TRACKED VEHICLES
E 109 Misc Instr No 1

CARRIER, ARMoured, TRACKED, 15-TON (FV 430 SERIES)

TECHNICAL HANDBOOK - MISCELLANEOUS INSTRUCTION

Fig 1 - Engine front cover ('early' Mk 4F engine)

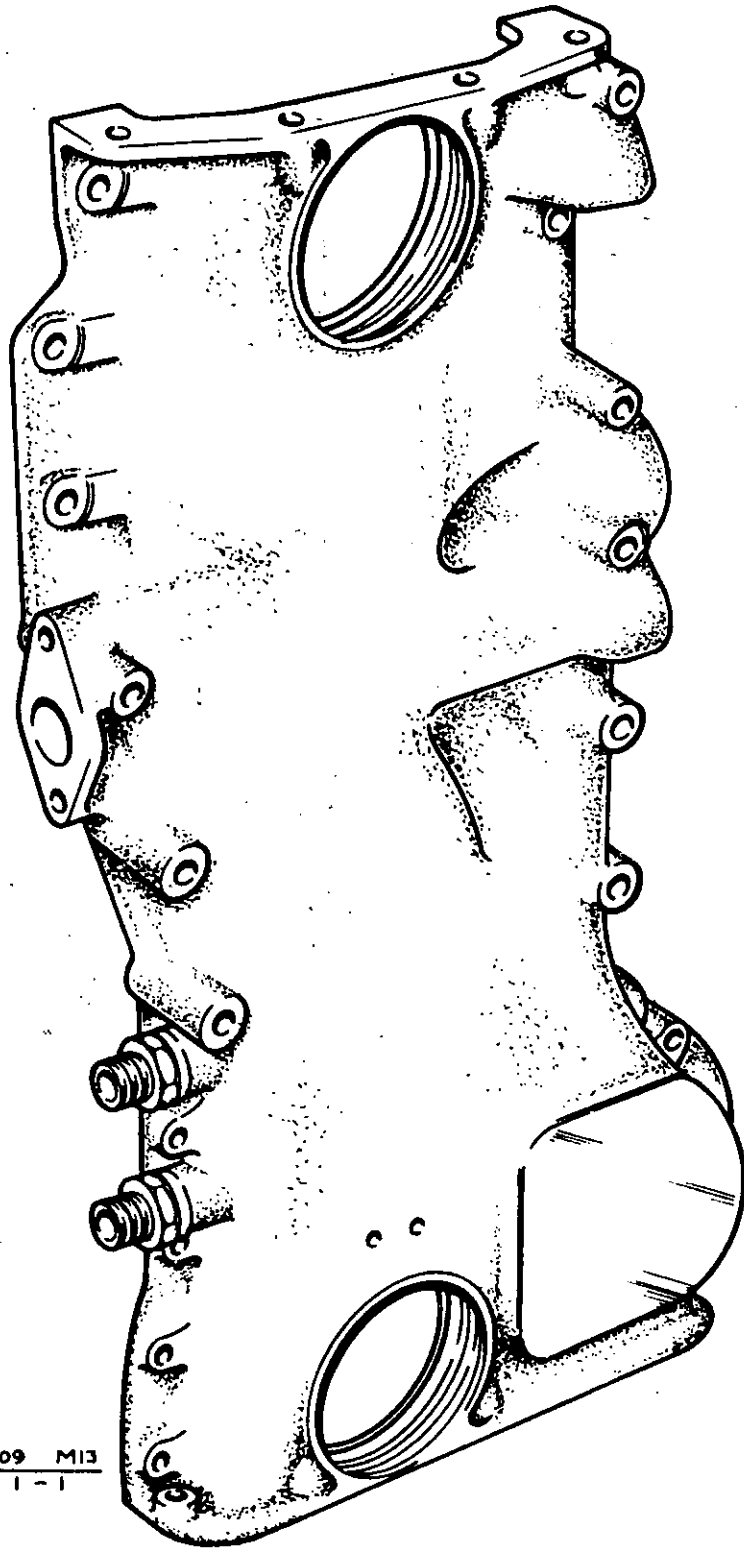
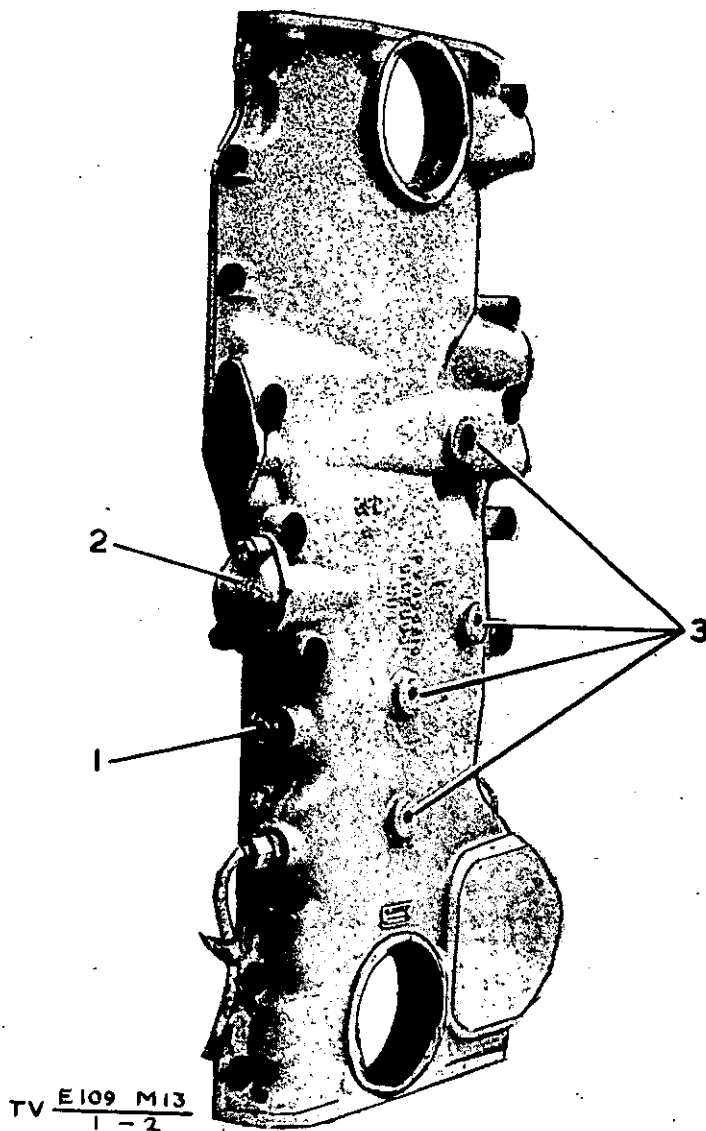
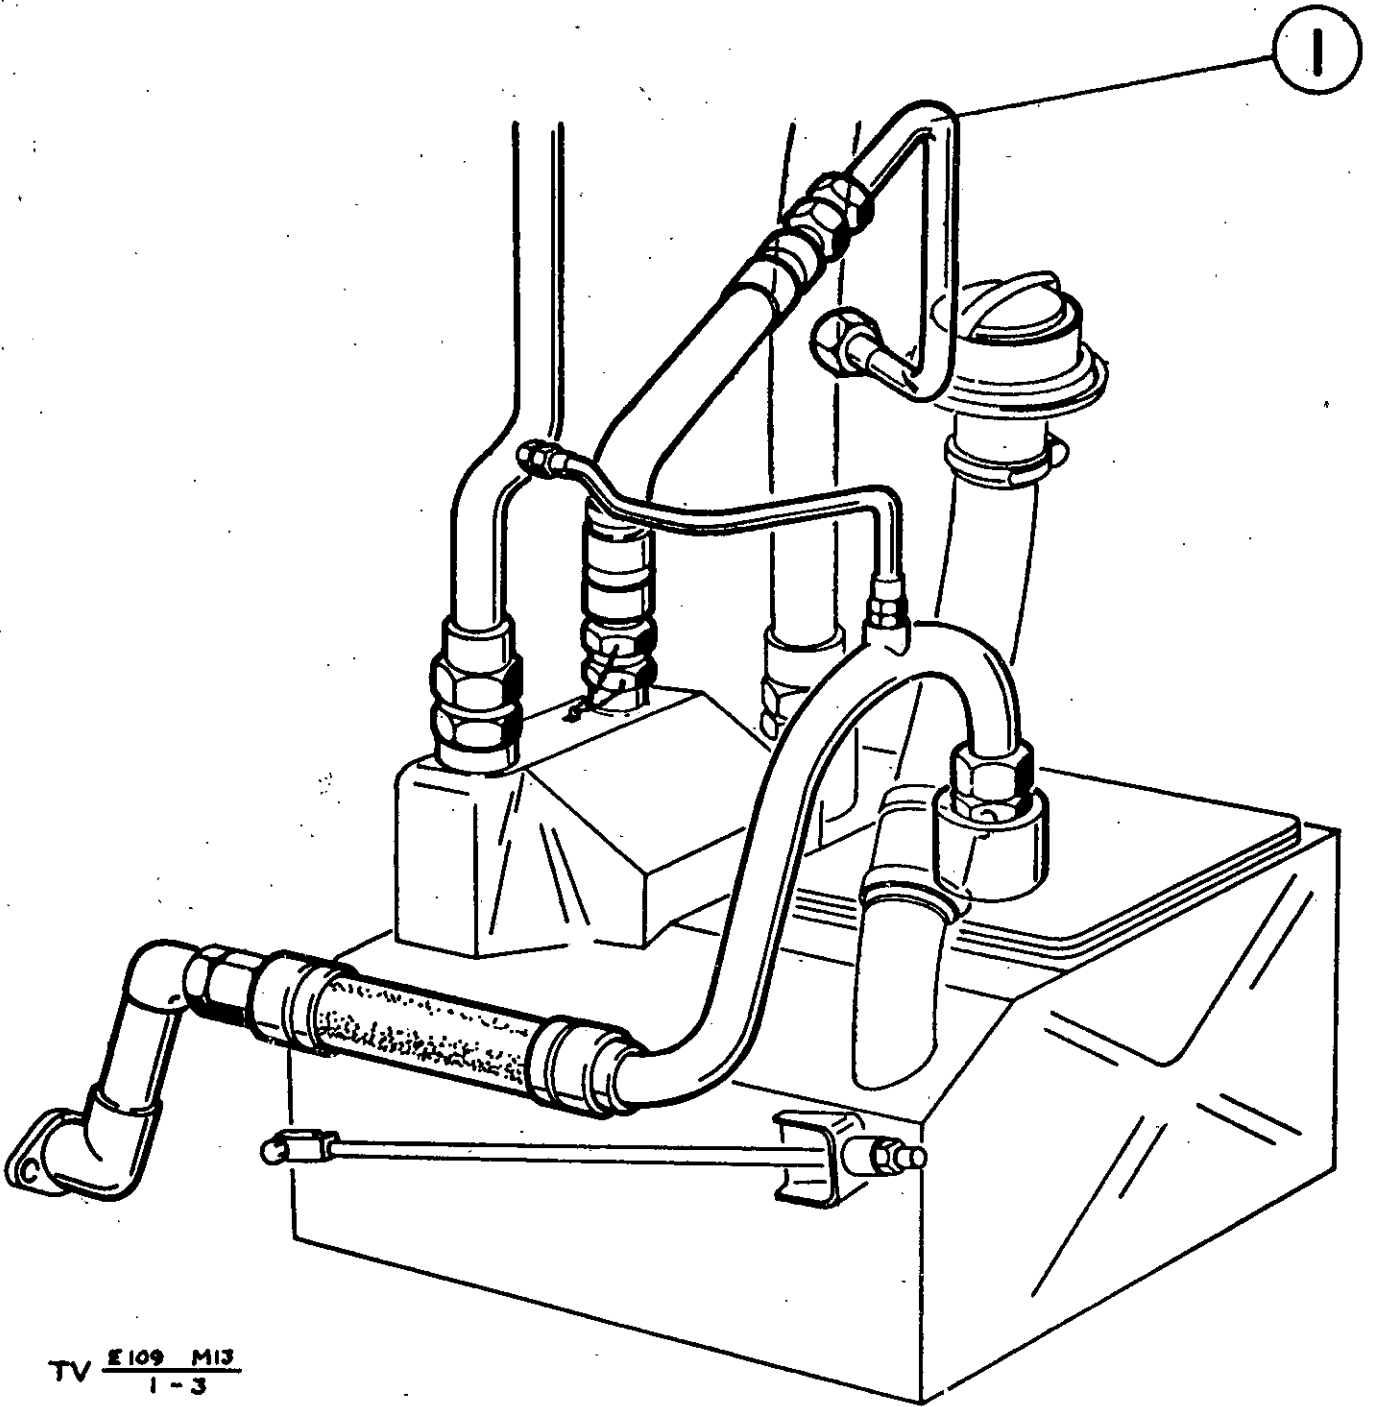
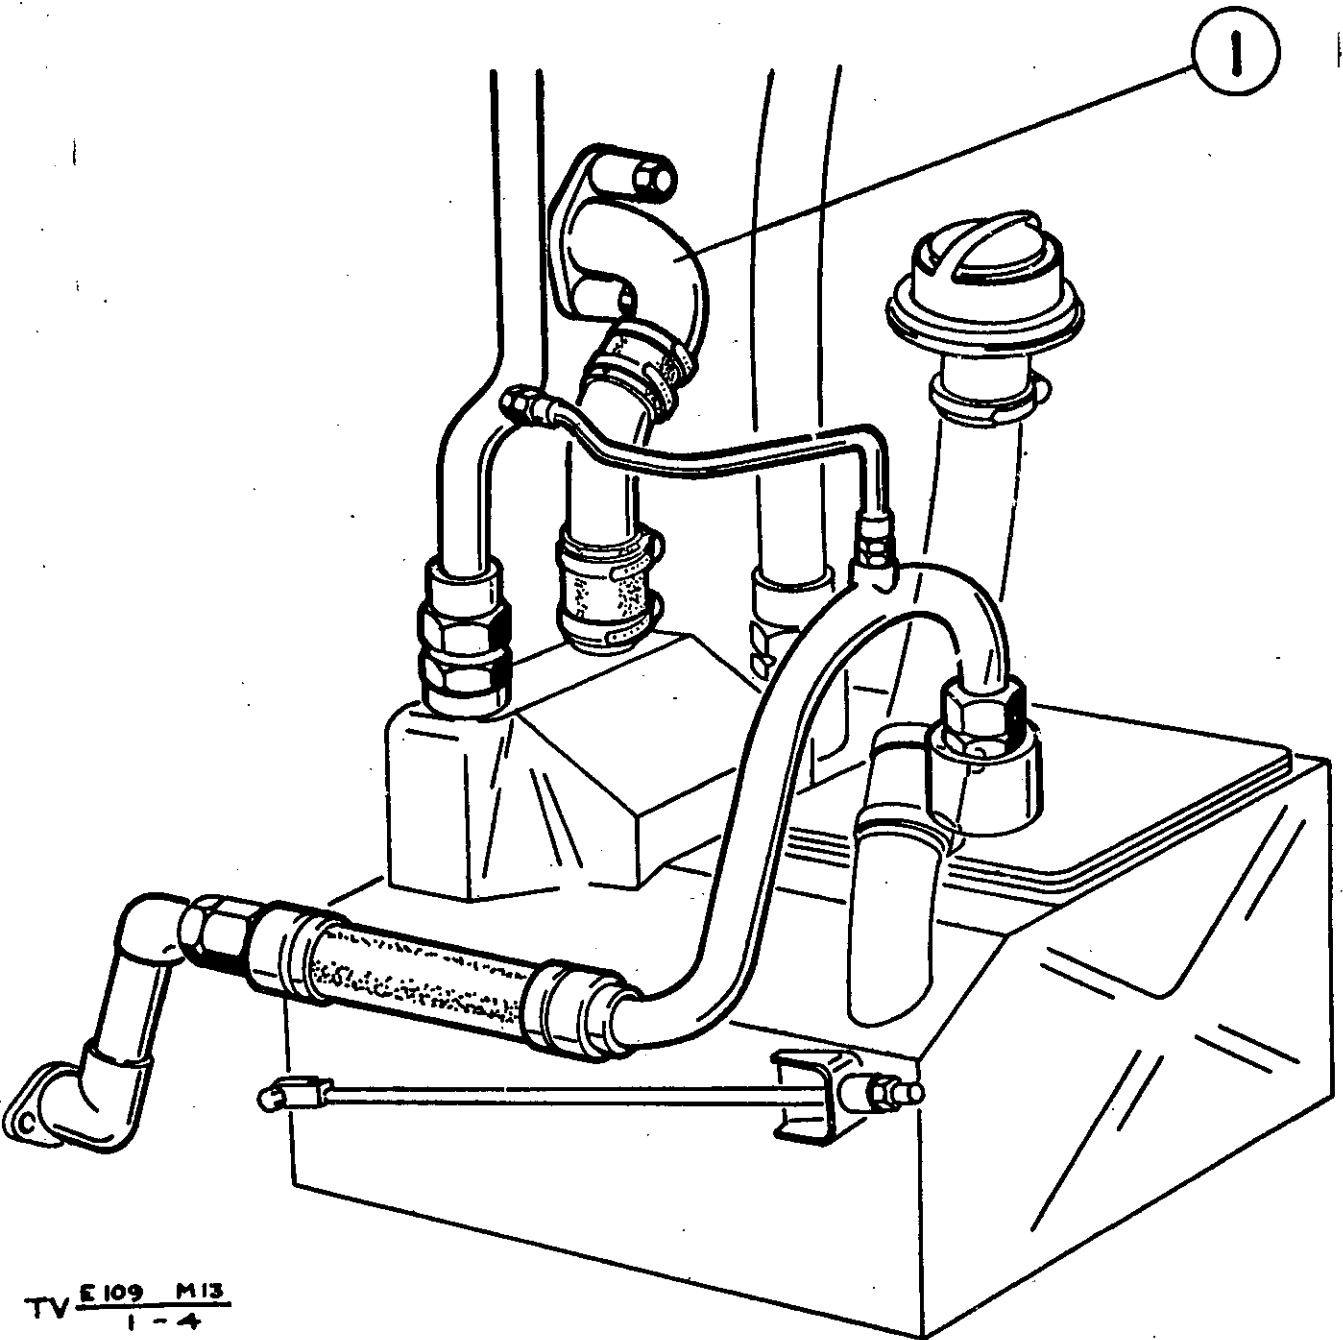
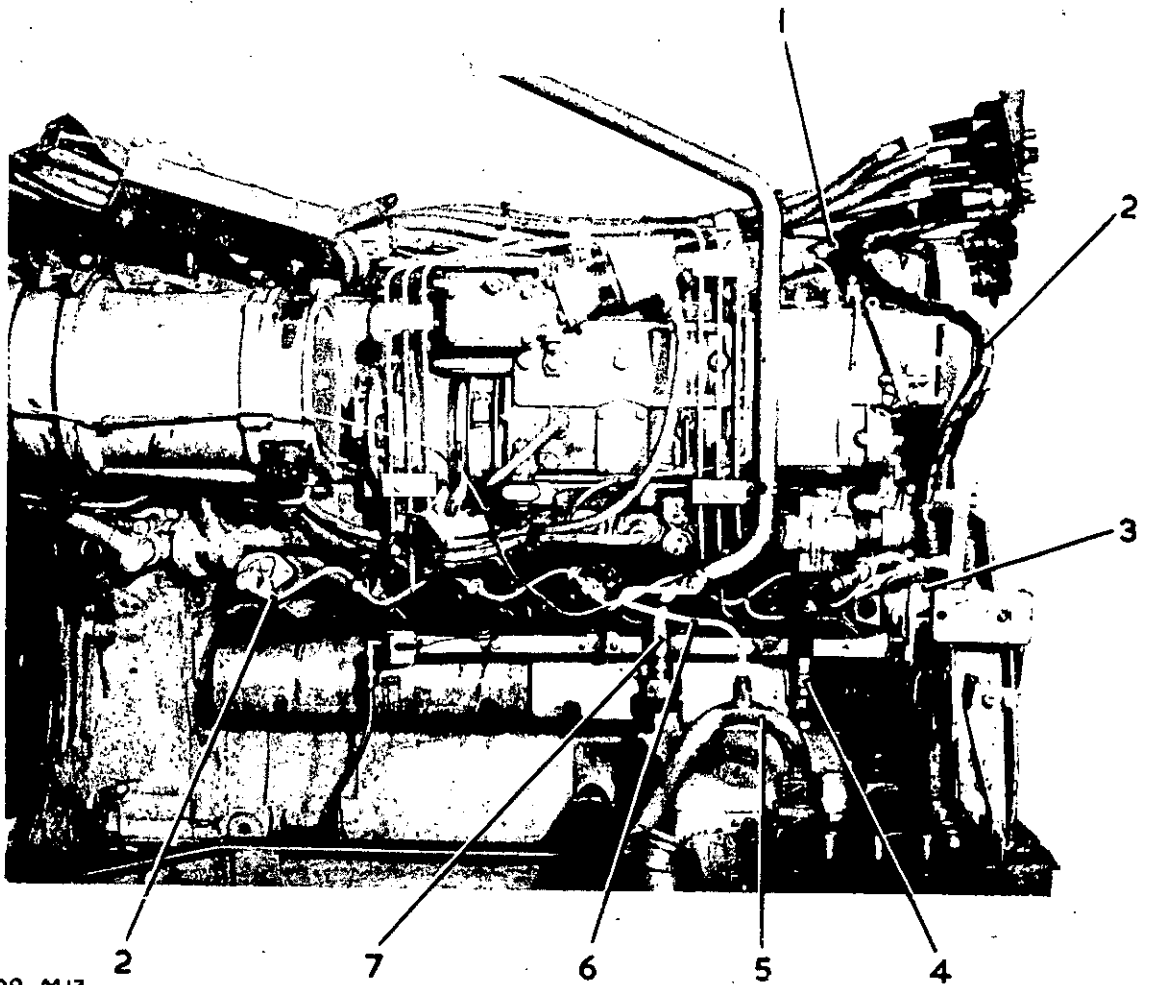
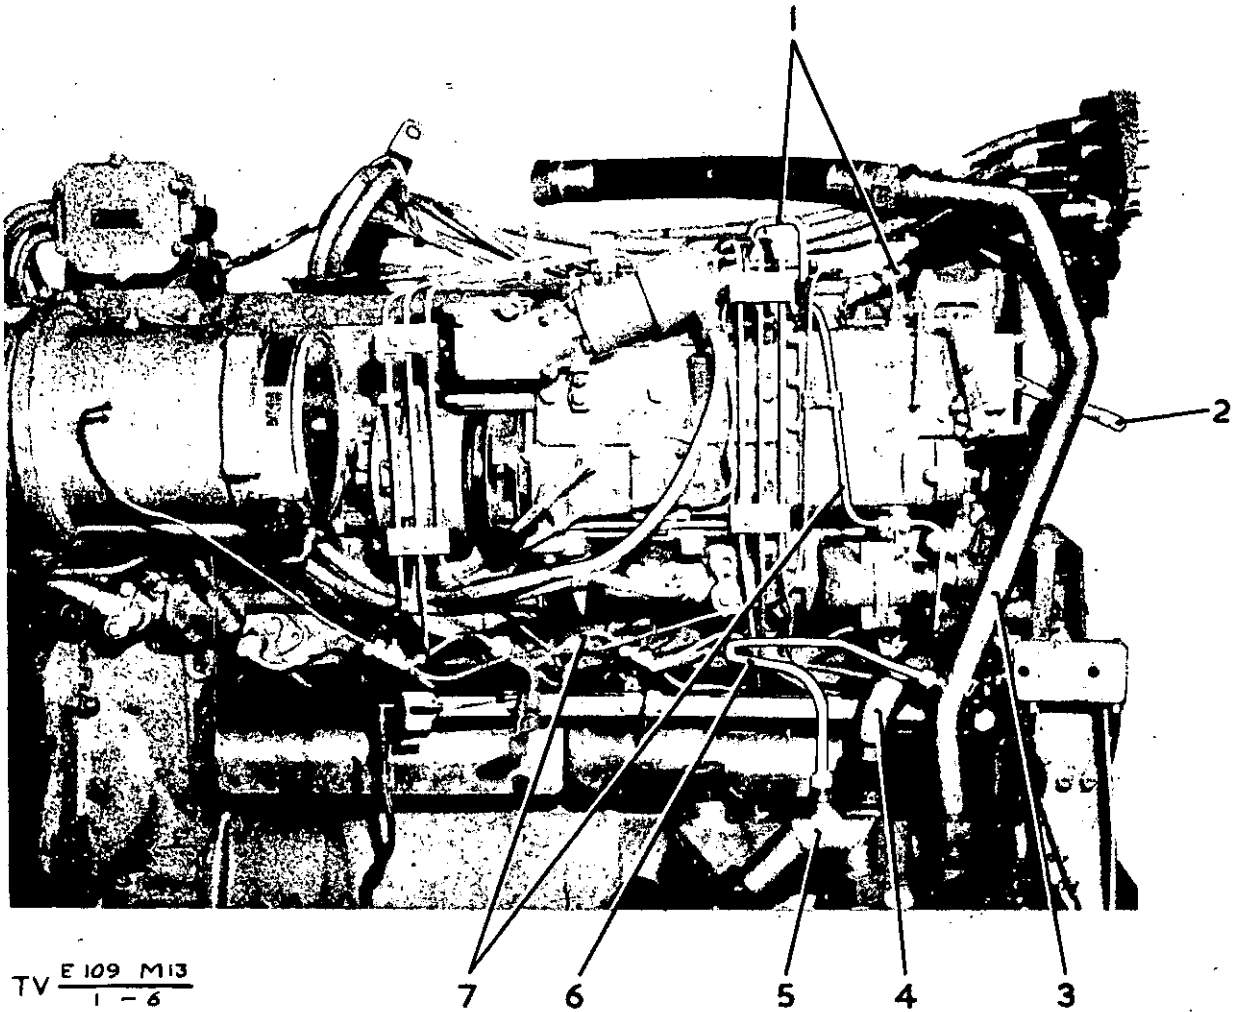
(1) An 'early' Mk 4F power pack refers to a pack assembled in production prior to the introduction of Approval 29314 and not subsequently modified in accordance with Tkd Veh E 107 Mod Instr No 32. An 'early' power pack is one fitted with a small bore front crankcase breather pipe, engine front cover to oil tank. For identification, see Fig 3.

(2) A 'late' Mk 4F power pack refers to a pack which has Approval 29314 incorporated in production or has been modified in accordance with Tkd Veh E 107 Mod Instr No 32. A 'late' power pack is one fitted with a large bore front crankcase breather pipe, engine front cover to oil tank. For identification, see Fig 4.

A	B	C	D	E	F	G
2.a.	Installation of 'late' Mk 4F engine to Mk 6F power pack			Modify as in Serial 1.a., 1.b. and 1.d.		
b.		Auth A/58/ MODS/1237	Tkd Veh E 107 Mod Instr No 14	Remove blanking cover (FV 142014) from engine front cover to allow fitting of large bore breather pipe. Remove 5/8 in. UNF d.e. union from small bore breather aperture in engine front cover and fit blanking plug	LV10/4730-99-865-2369 Plug, screwed, blanking, 5/8 in. UNF LV10/5310-99-865-1479 Washer, flat, aluminium, 5/8 in. i.d.	See Fig 2 and 4

3.	Installation of 'early' Mk 4F engine to 'late' Mk 4F power pack	-	-	Modify as in Serial 1.c.		
4.a.		29314	Tkd Veh E 107 Mod Instr No 32	Introduction of large bore front crankcase breather pipe and oil tank modified to accommodate pipe	LV9 ACR/MOD 29314 Mod set: Power pack.	Small bore breather pipe could be fitted but this alternative is retrograde and not recommended. See Fig 4 and 6

b.	Installation of Mk 6F engine to 'early' Mk 4F power pack	Auth A/58/ MODS/1055	Tkd Veh E 107 Mod Instr No 15	Remove adapter 1.3/8 in. - 1.5/8 in. UNF (LV9 ACR/4730-99-867-4754) from engine oil tank. Fit union d.e. 1.5/8 in. UNF to oil tank. Fit oil suction pipe assembly, tank to sump (FV650905)	LV9 ACR/2990-99-808-1277 Oil pipe assembly LV9 ACR/2990-99-808-1278 Oil pipe LV9 ACR/2990-99-808-1279 Pipe assembly LV6 MT6/4720-99-805-7786 Hose, rubber, 1.3/8 in. i.d. (2) LV6 MT1/4730-99-200-8881 Clip, hose, worm drive 1.1/2 in. to 2.1/8 in.(4) LV6 MT1/4730-99-804-4698 Union, d.e., 1.5/8 in. UNF LV9 ACR/5310-99-867-4755 Washer, flat, copper, 1.5/8 in. i.d. LV6 MT1/5330-99-808-1282 Ring sealing	These items are fitted to Mk 6F power pack. See Fig 6

Fig.1 - Gearbox oil temperature gauge

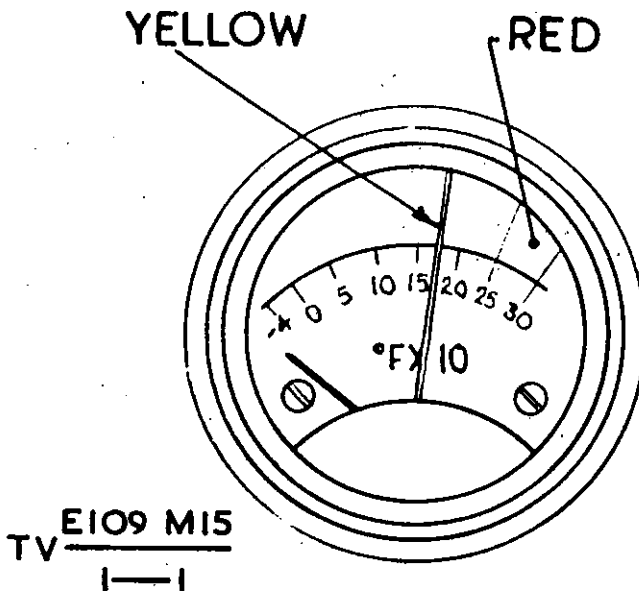
Additional coloured marking is added to the dial of the oil temperature gauge to facilitate checking the gearbox oil level and to ensure that the gearbox is operating at a safe working temperature.

a. Remove the gearbox oil temperature gauge from the instrument panel. Expose the dial of the gauge by unscrewing the cap from the body and removing the glass cover, 'O' seal ring, perspex cover, a second 'O' seal ring and pointer pivot guard.
